EnergyConnect (NSW – Western Section)

Amendment Report

April 2021

Figure 2-19 Revised EIS figure 5-4 showing corrected extent of proposed realignment of the Broken Hill to Buronga 220kV transmission line (Line 0X2)

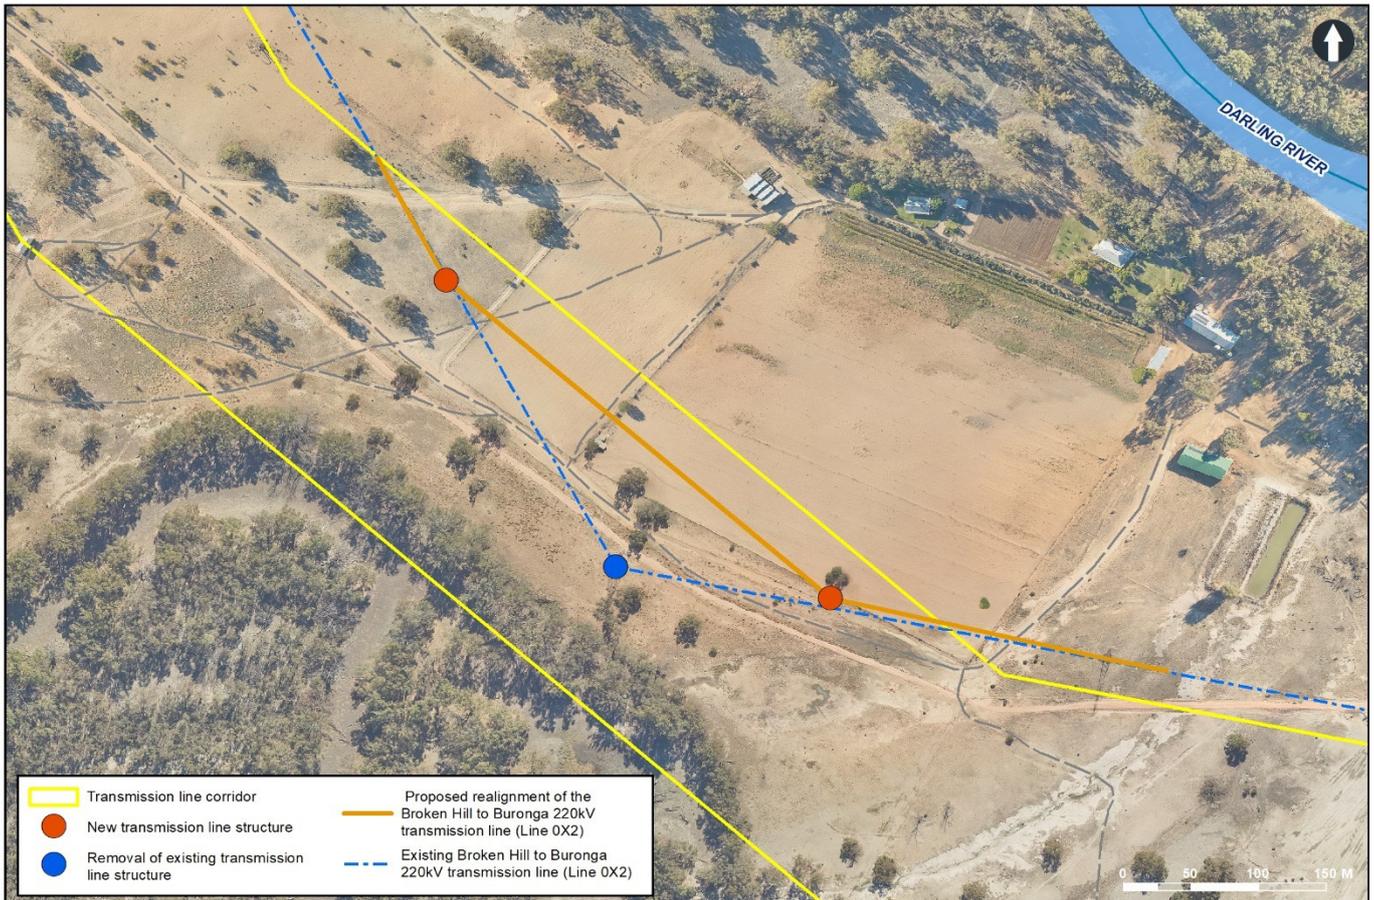
Section 5.3.1 of the EIS identified that as part of the proposal, a short section of the existing Broken Hill to Buronga 220kV transmission line (Line X2) in proximity to the Darling River would be realigned to accommodate the new 330kV transmission line. As described in the EIS, this realignment would be for around 700 metres in length and require two new monopole structures to replace one existing transmission line structure with the redundant tower to be decommissioned and removed from the easement.

Following exhibition of the EIS it was noted that while the text provided in the EIS correctly identified the diversion as an around 700 metres, the extent of the realignment shown was not shown correctly on the corresponding figure (Figure 5-4). Figure 5-4 indicated a greater extent of proposed realignment than is actually proposed to occur.

This figure has now been corrected and is shown in Figure 2-19.
